**Bethesda-Chevy Chase Middle School #2, Mandatory Referral, MR2014048**

Completed: 03/19/15

**Description**

**Summary**

Highest retaining walls cross section

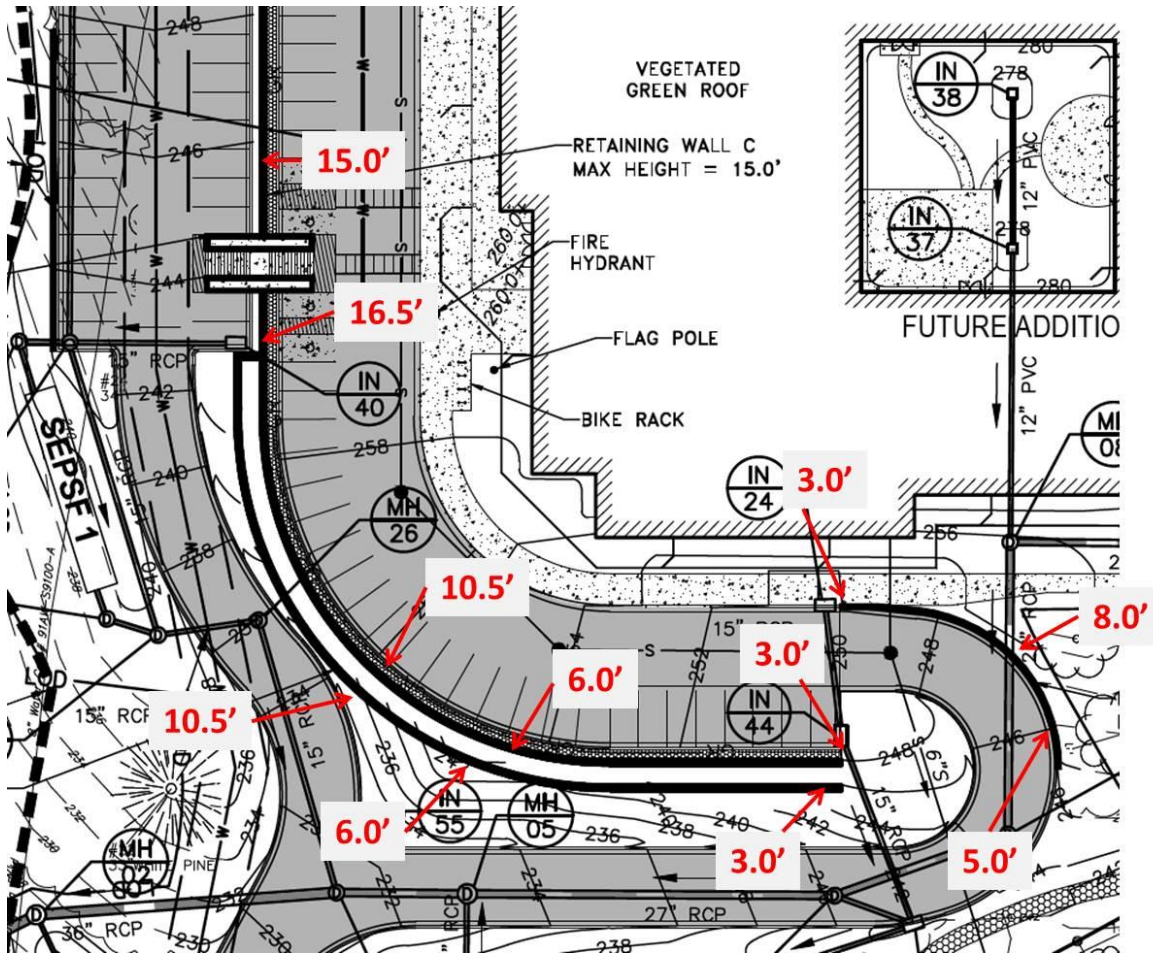
While the architecture responds to the site, the combination of the building design and site’s constraints of size and topography result in a number of issues. The four-story building and sloping site create a height differential of approximately 100’ from the parent drop-off loop entrance on Saul Road to the top of the west façade of the proposed building.

A major issue created by the combination of the school program and site topography is the numerous retaining walls (Attachment 7). The site has less than eight acres of relatively flat area and the rest has steep slopes and forested areas. The MCPS's middle school program will not easily fit in this space without using retaining walls. The highest retaining walls are created by the parent drop-off loop. The plans currently show the entrance to the parent drop-off loop at the lowest point of the site, an elevation of 222', with a first floor elevation of 260'. These two design decisions result in a series of retaining walls with two of the retaining walls at 10.5-foot high each, at one location. When the safety fence is included, the total height from bottom of wall to the top of the visible structural is more than 24' feet.

Proposed parent drop-off loop retaining walls

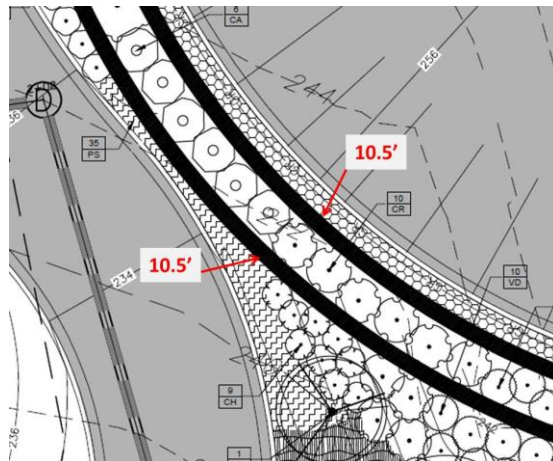
MCPS proposes to landscape in front of the lower wall and between the two walls, but the area where the walls are highest has the least amount of landscaping. Although the MCPS has used all design and landscape techniques to minimize the negative visual impacts of these walls, staff is concerned that the proposed retaining walls are excessive and can be reduced through further design refinements and changes in design and layout of the parent drop-off and parking area. The figure below indicates the proposed heights of retaining walls. All retaining walls will have fences on top of the walls (for safety reasons) in addition to the heights shown below.

**Alternative concept with structured parking**

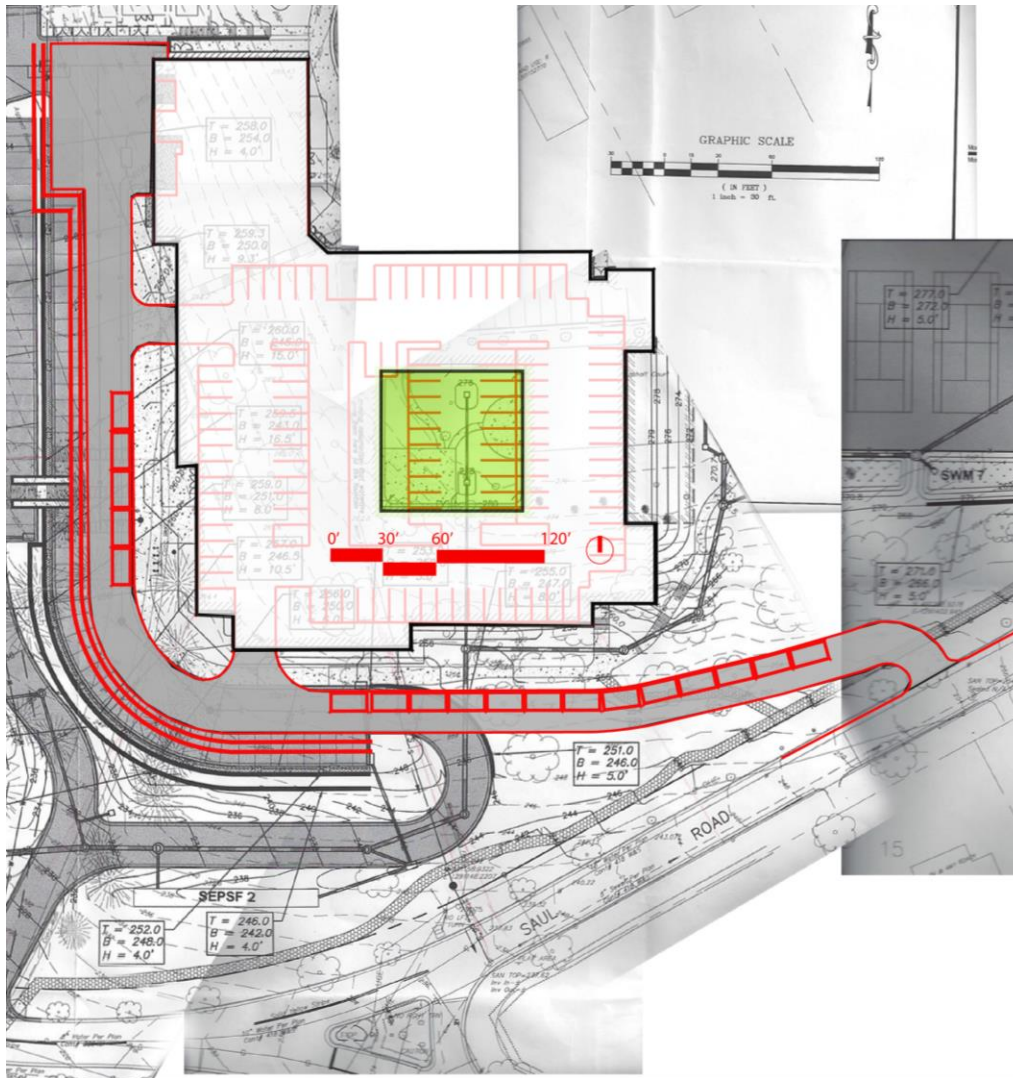
Staff believes that this site and the school program call for outside-the-box solutions such as structured parking to solve some of the site design problems. Staff produced a concept plan that showed that structured parking was a feasible solution and it reduced the impervious area on the site, saved significantly more specimen trees, and reduced the loss of high priority forest while accommodating the same building program and facilities. The figure below shows this concept.

MCPS's alternative layout of the parent drop-off loop

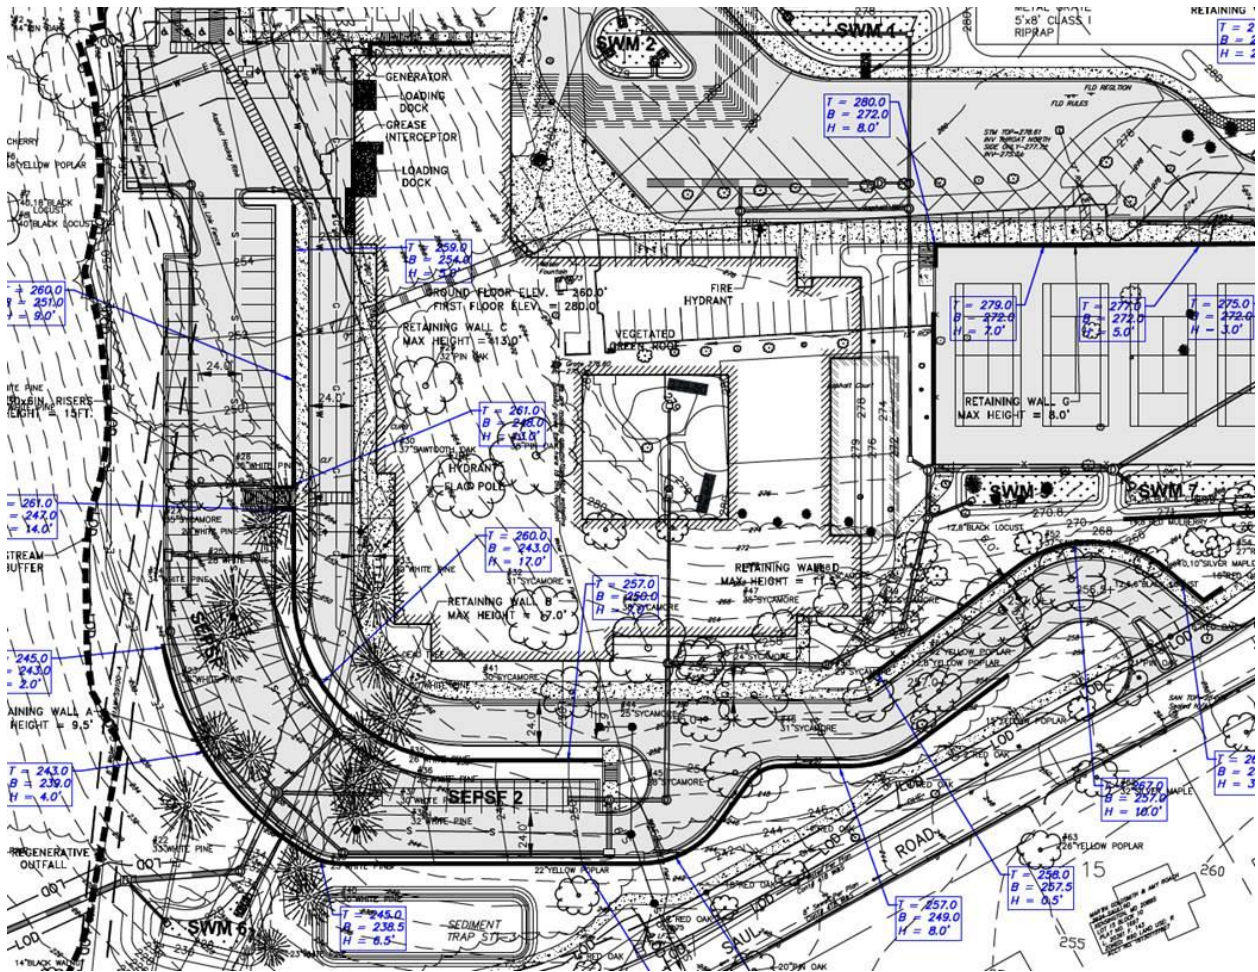
Since MCPS did not consider this option and the current schedule does not permit such major revisions to the design of the project, staff has explored other options that can maintain the MCPS's construction schedule and still reduce the development's footprint saving forested areas, reducing the amount and height of proposed retaining walls and reduce the impact to significant trees. At the urging of the Planning staff, MCPS developed an alternative plan (shown below) for the parent-drop-off and parking access areas.

Staff analyzed this alternative for its impact on high priority forest and significant trees and found that, compared to the submitted plans, it saved more high priority forest and variance trees, reduced the retaining wall heights, improved pedestrian circulation, and improved sight distances. Although staff found this alternative to be an improvement over the submitted plan, staff believes that this alternative needs further improvement and can be refined to reduce the height of the retaining walls and increase the forest and tree save areas.
